**WASTEWATER REPORT  
LATIGO TRAILS FILINGS 9 AND 10, 78 LOTS  
SOUTHWEST OF EASTONVILLE ROAD  
AND LATIGO BOULEVARD  
EL PASO COUNTY, COLORADO**

Project No. CS19409-115

October 7, 2021

**FILLING 9  
SEPTIC  
SUITABILITY  
MAP**

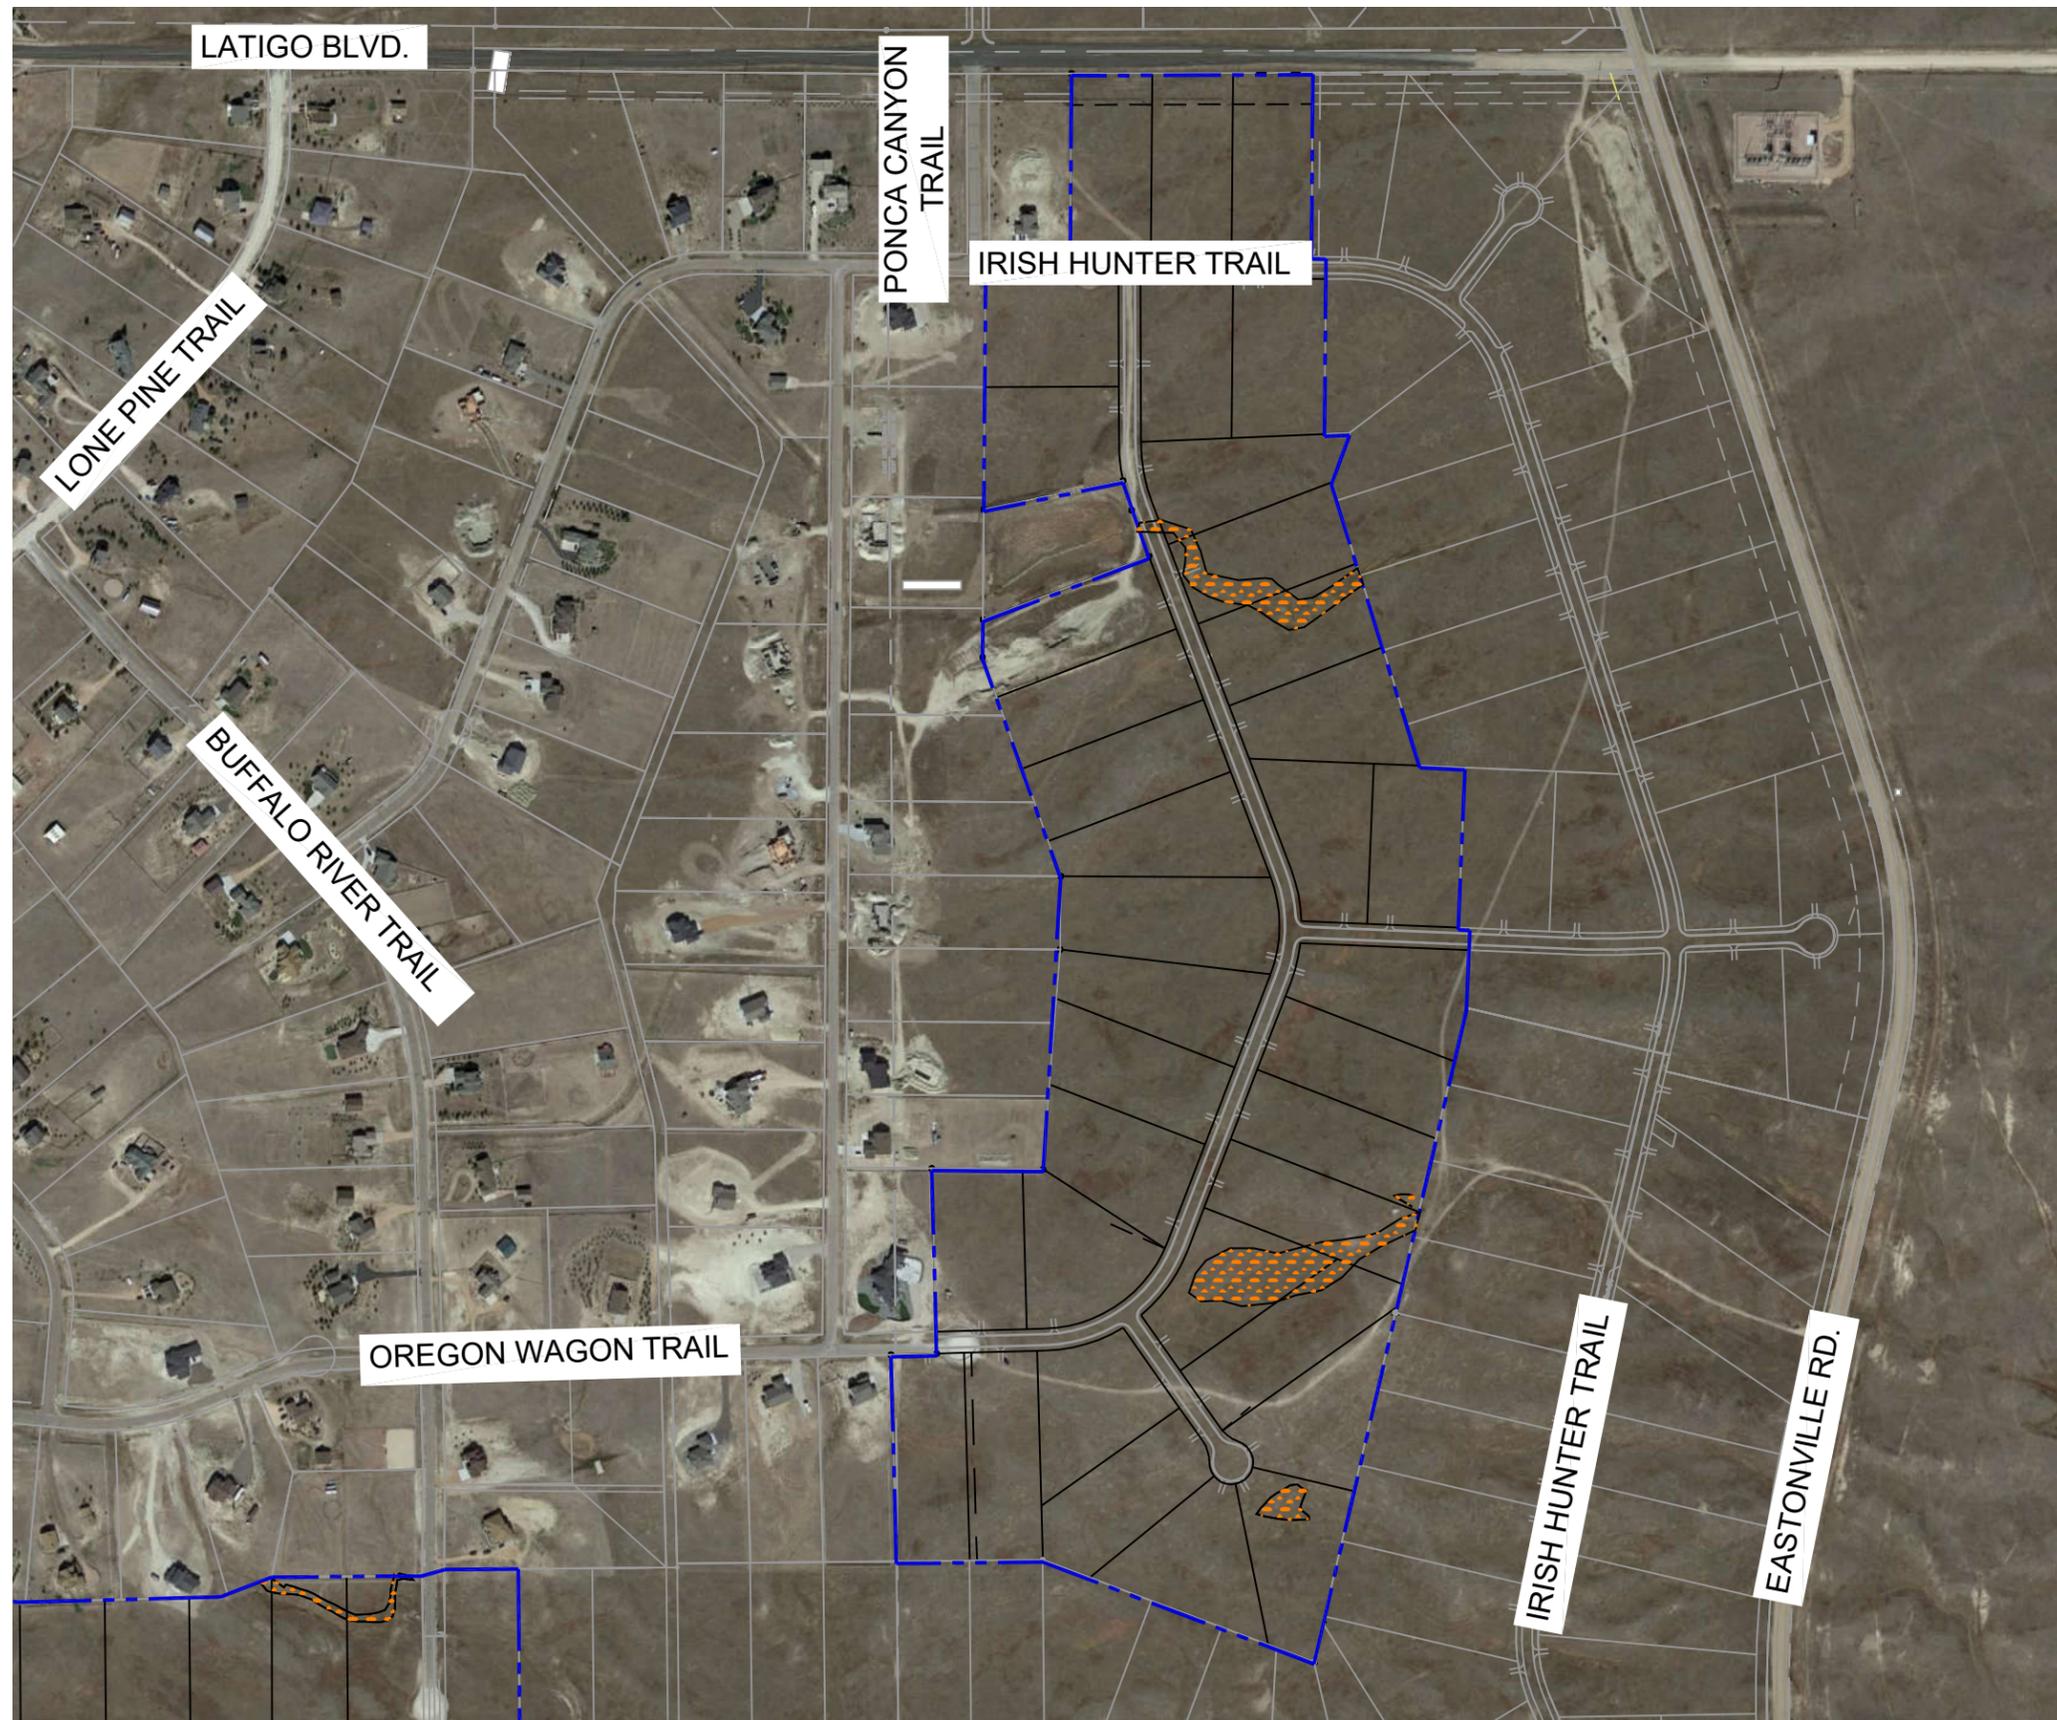
areas must be designated as no-build and a plat note needs to be added stating that septic systems cannot be located within drainage areas
